# COTTAGES AT GENERATION VILLAGE

## WILLARD, GREENE COUNTY, MISSOURI

PM: RS  
PC: RS  
PLAN SET NO. \_\_\_\_\_  
MASTER COVER SHEET  
ADDENDUM #2

ISSUE/REVISIONS  
12 AUG 2022 ISSUE SET  
03 NOV 2022 ADDENDUM #1  
22 SEP 2023 ADDENDUM #2

4 & 6-PLEX BUILDING PLANS

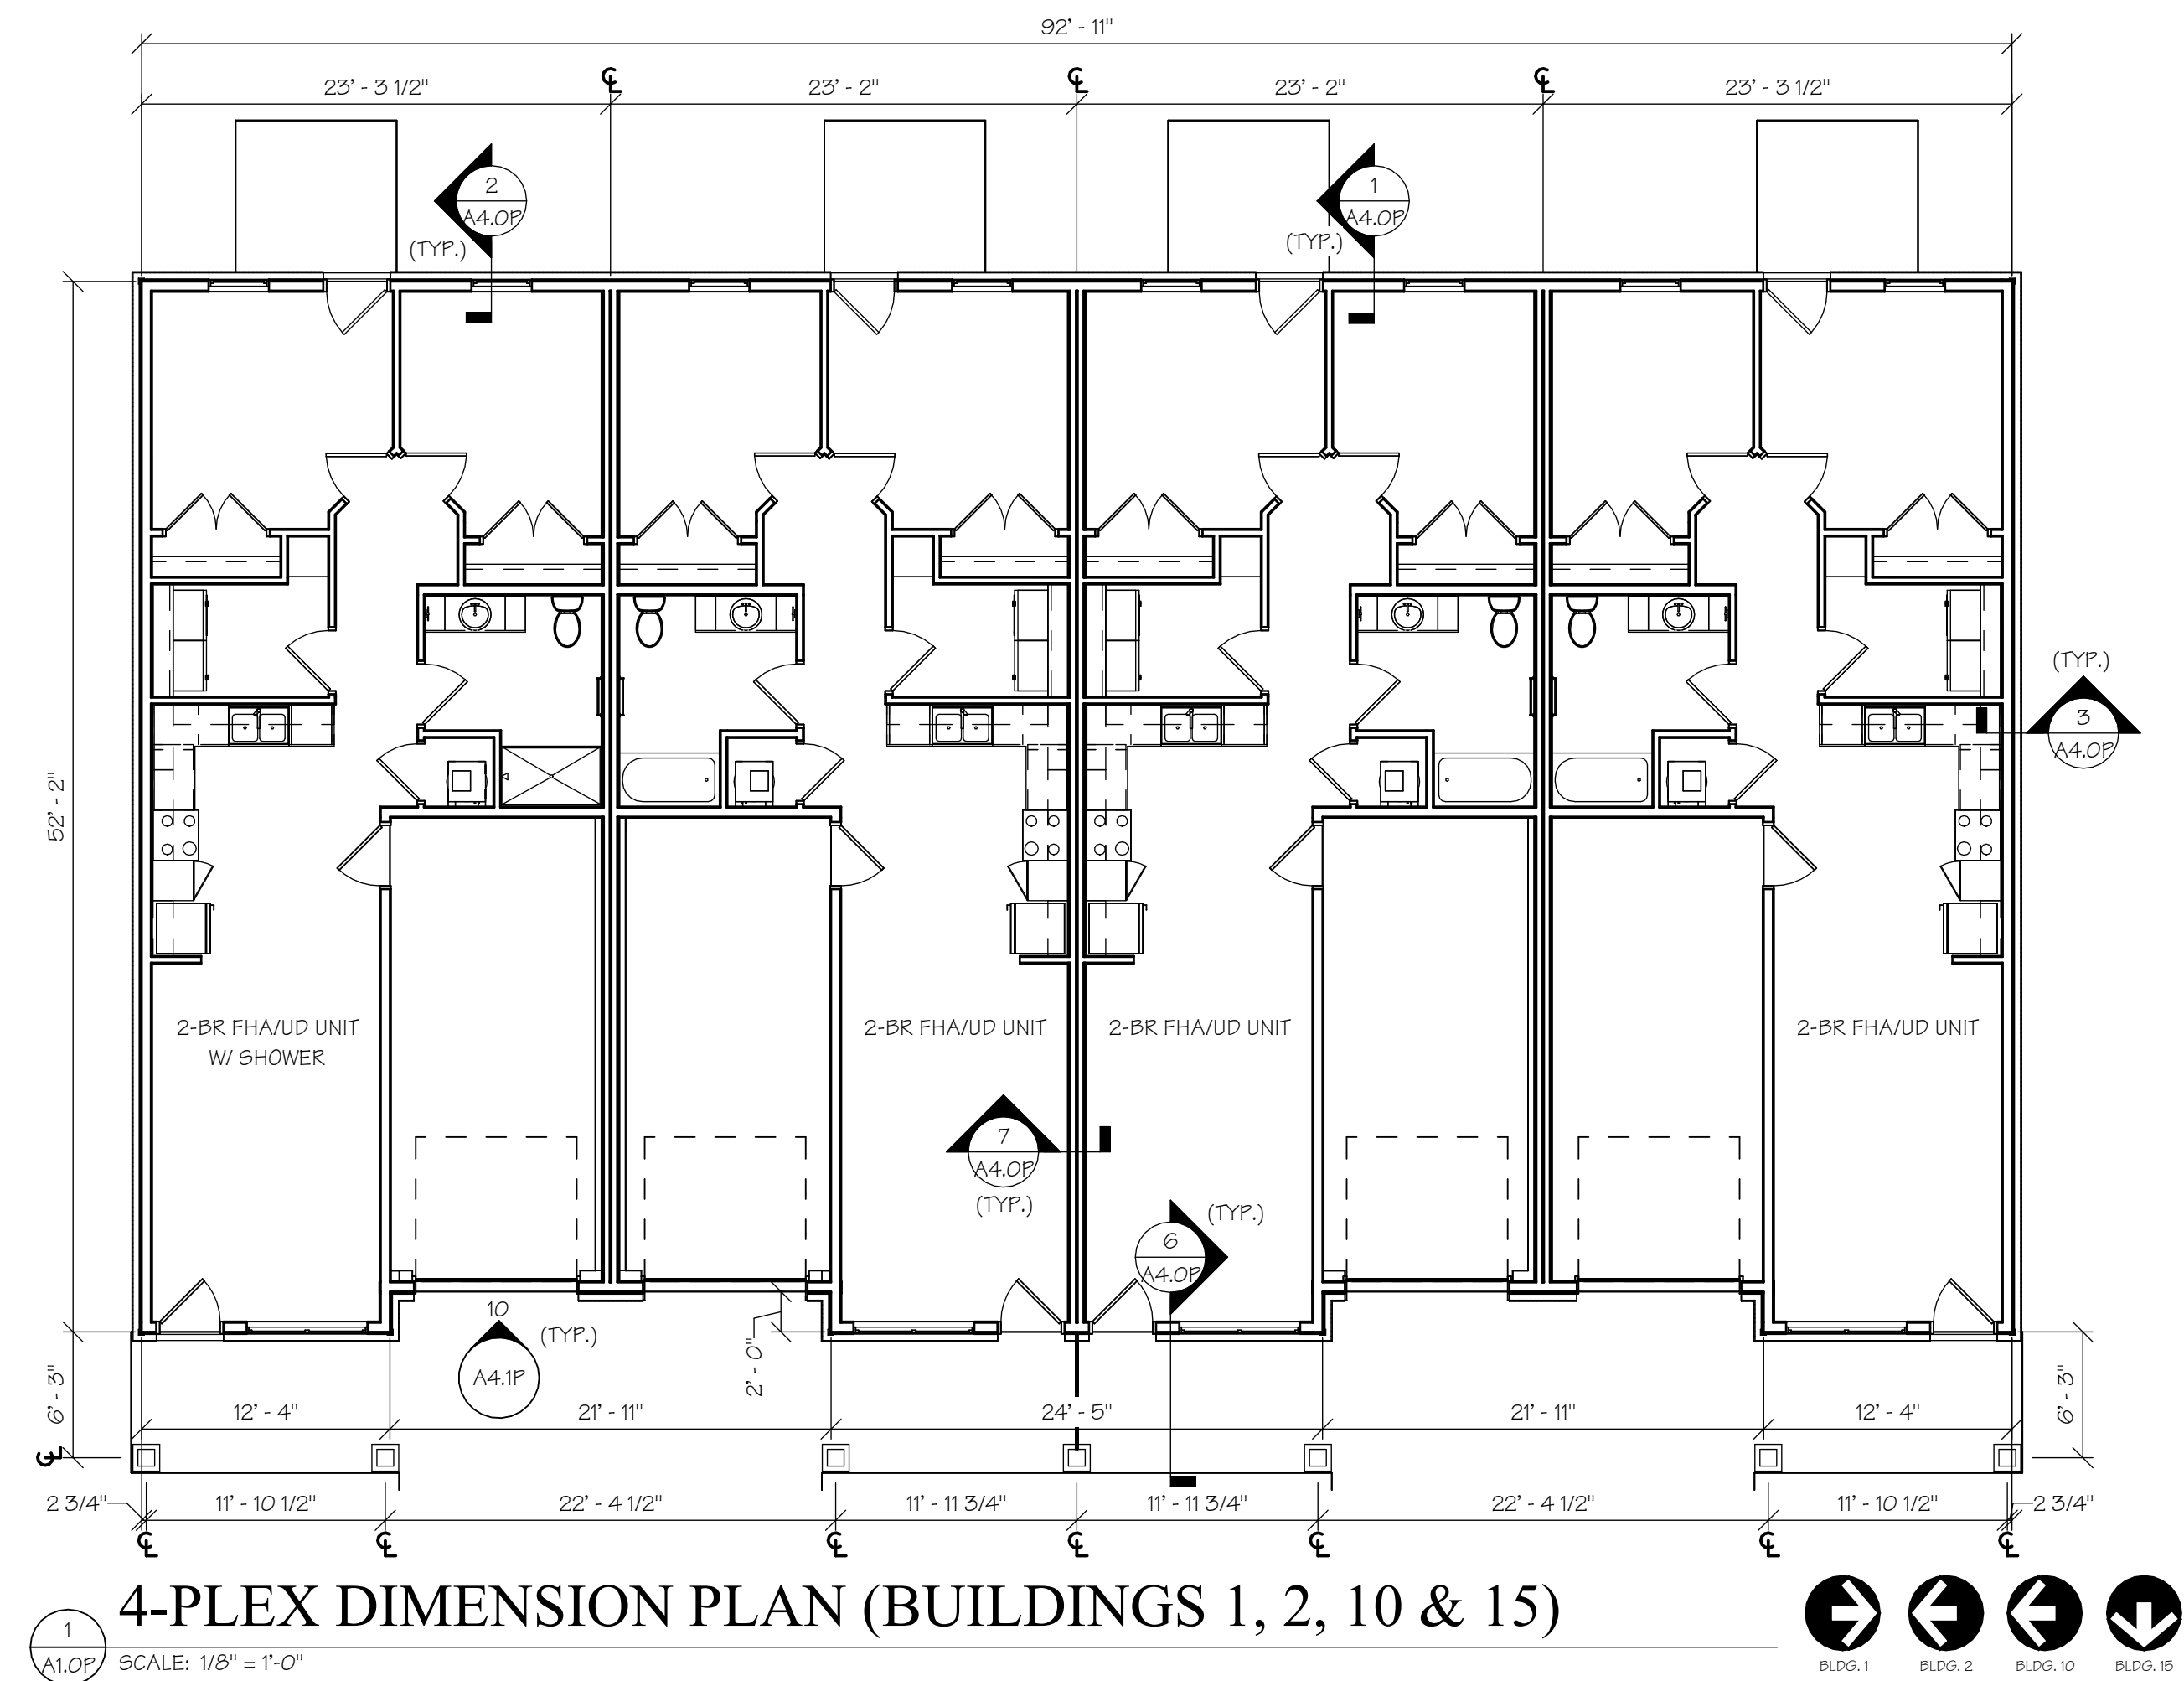
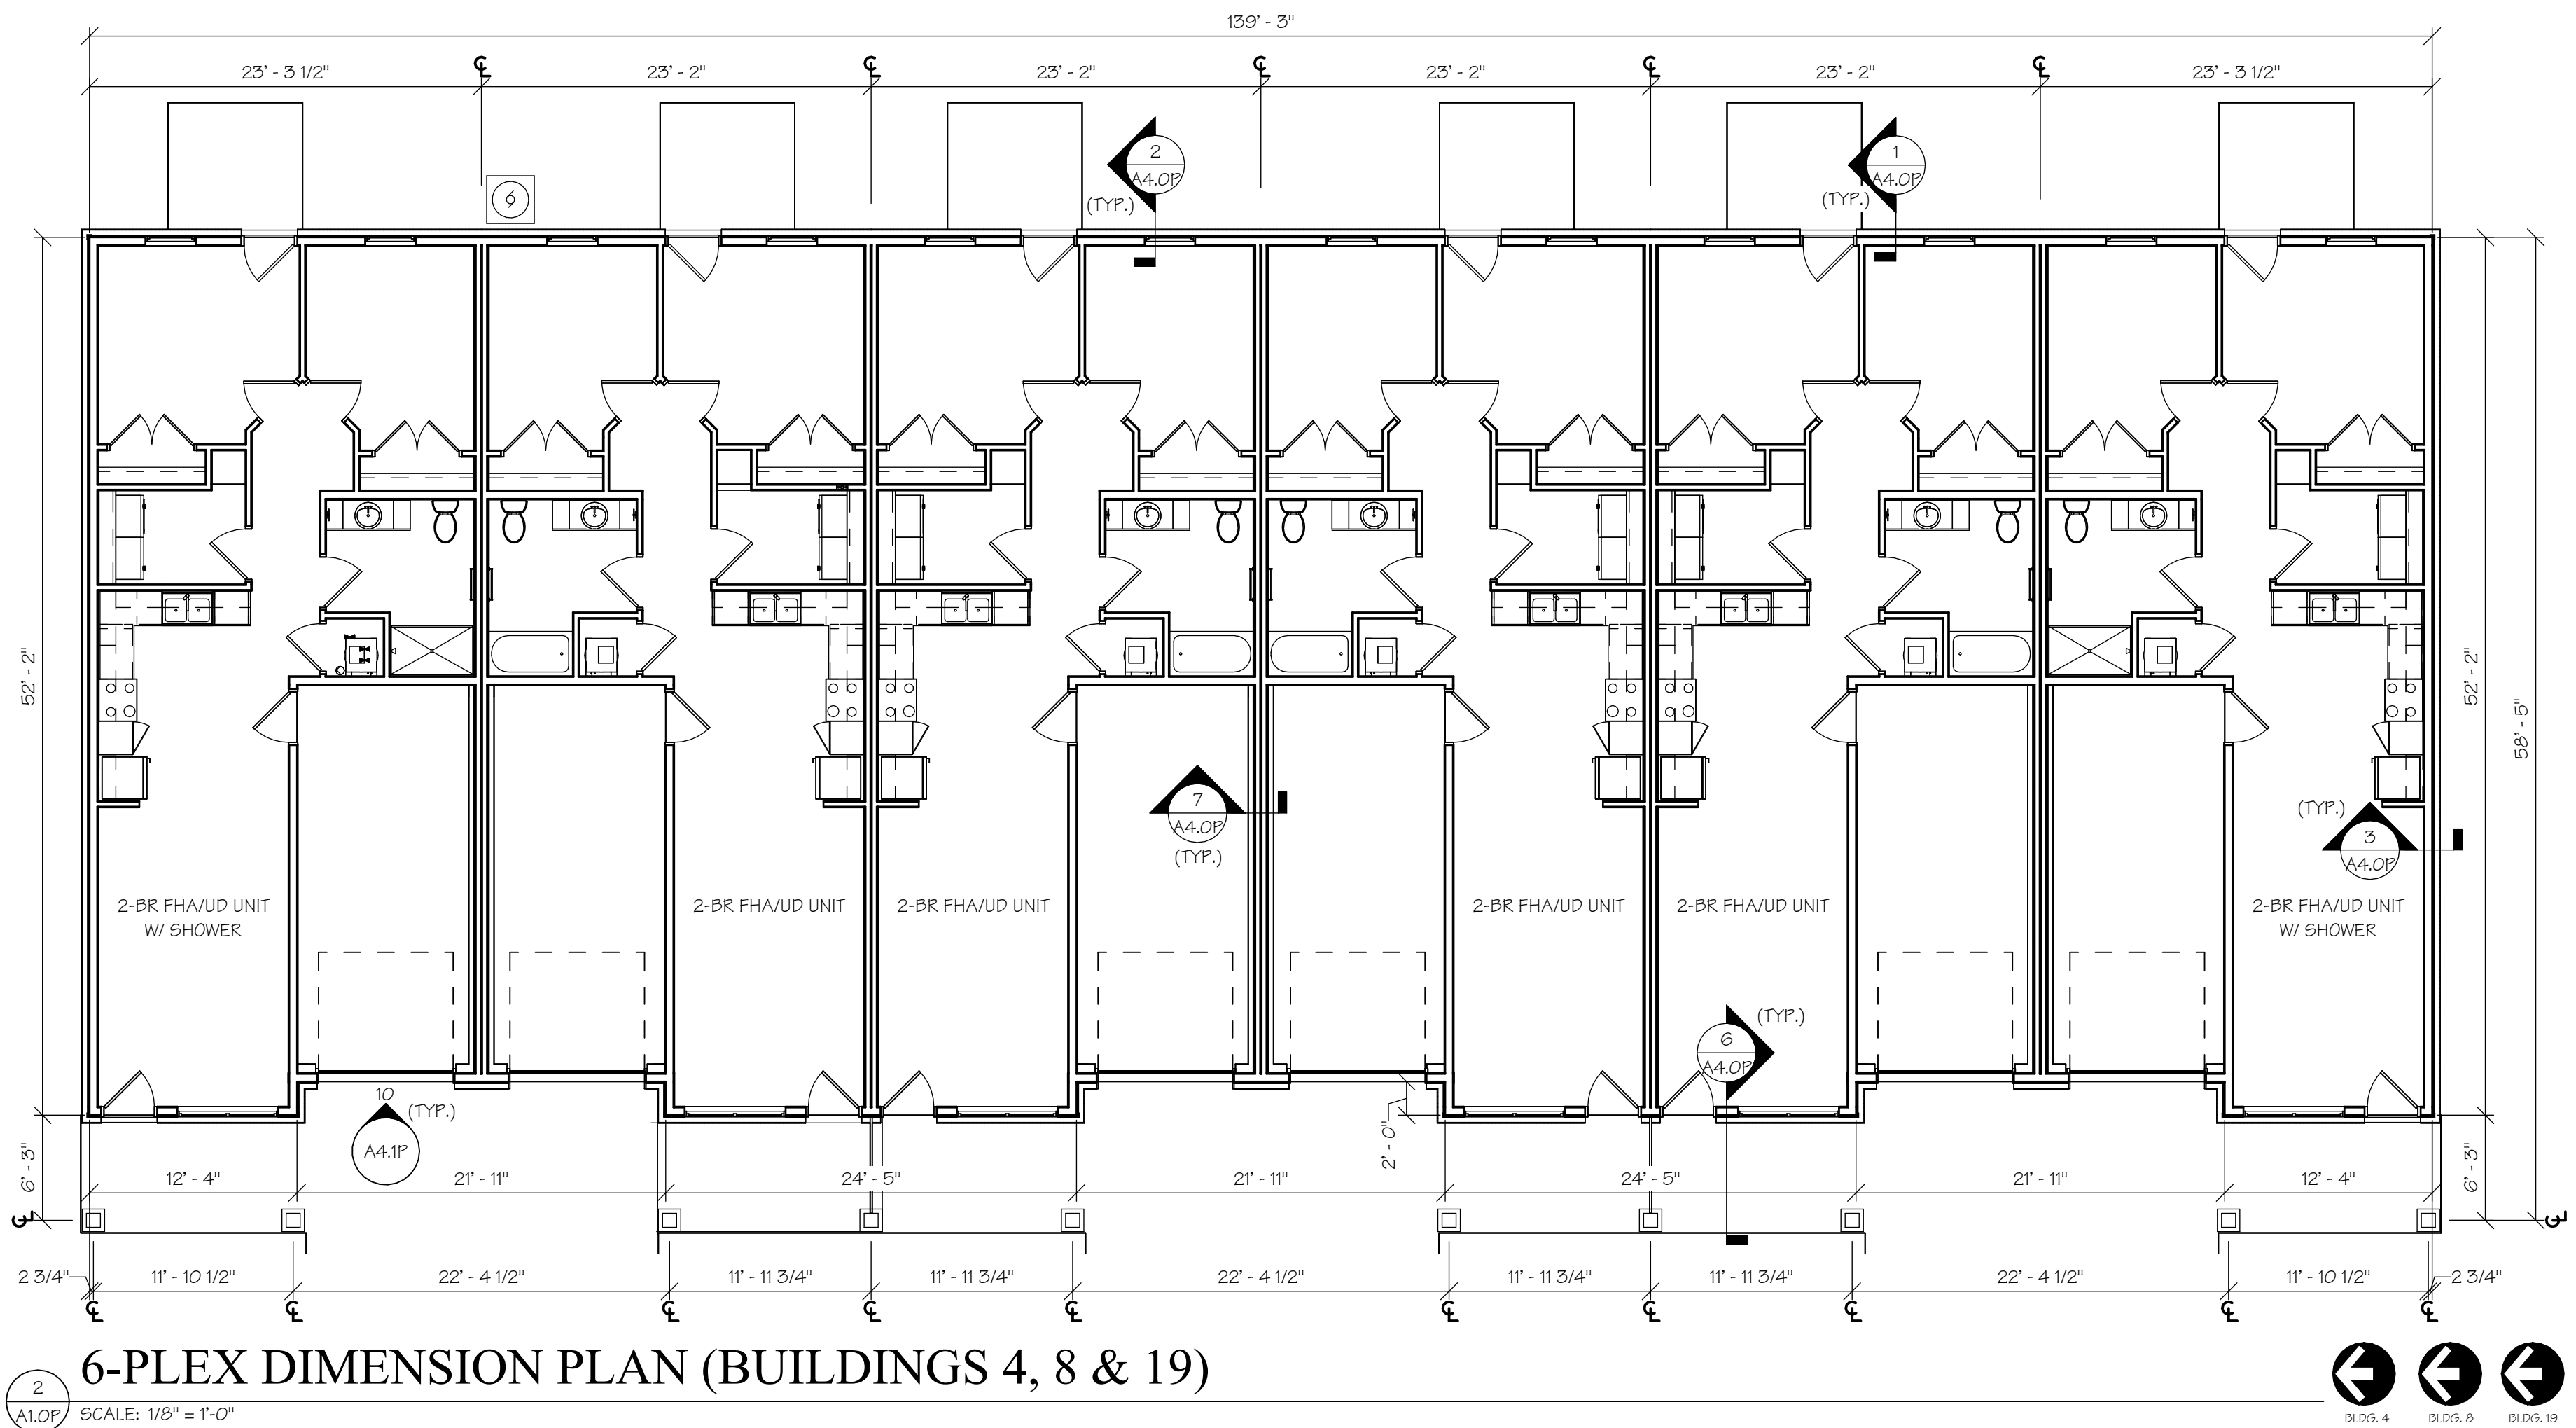
NOTE: DRAWINGS UPDATED TO MATCH REVISIONS  
TO DIMENSION PLANS ON SHEET A1.2P.

6-PLEX ACC. BUILDING PLANS  
ADDENDUM #1

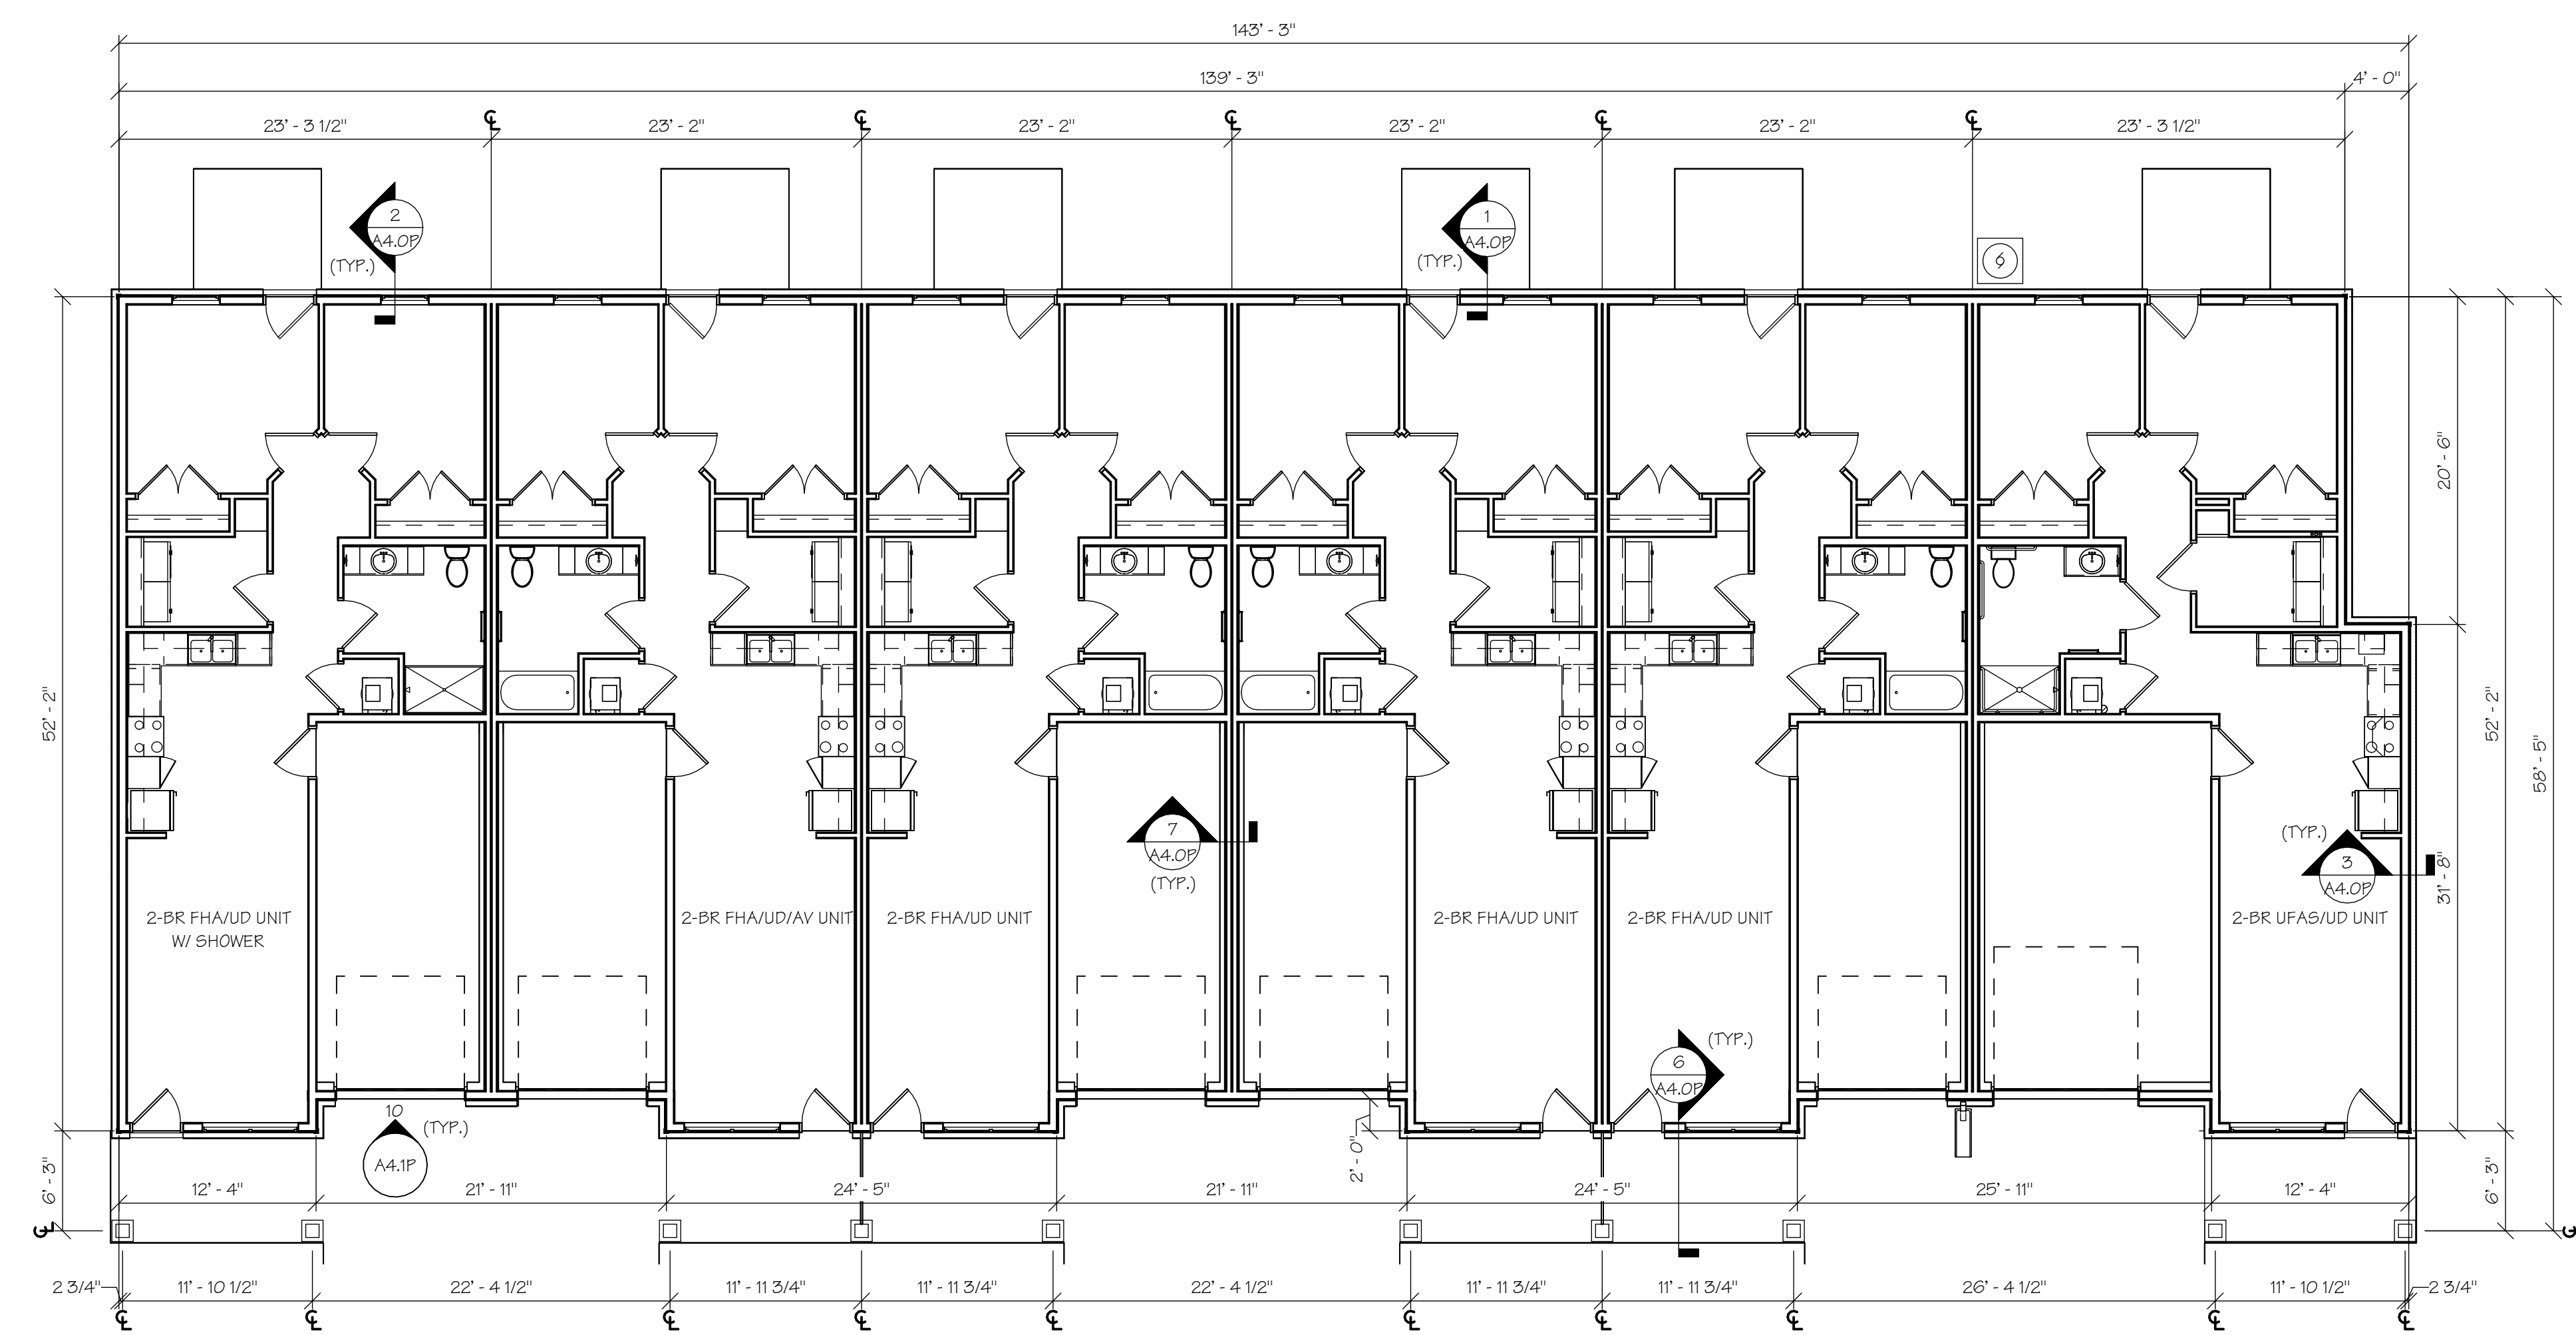
NOTE: DRAWINGS UPDATED TO MATCH REVISIONS  
TO DIMENSION PLANS ON SHEET A1.2P.
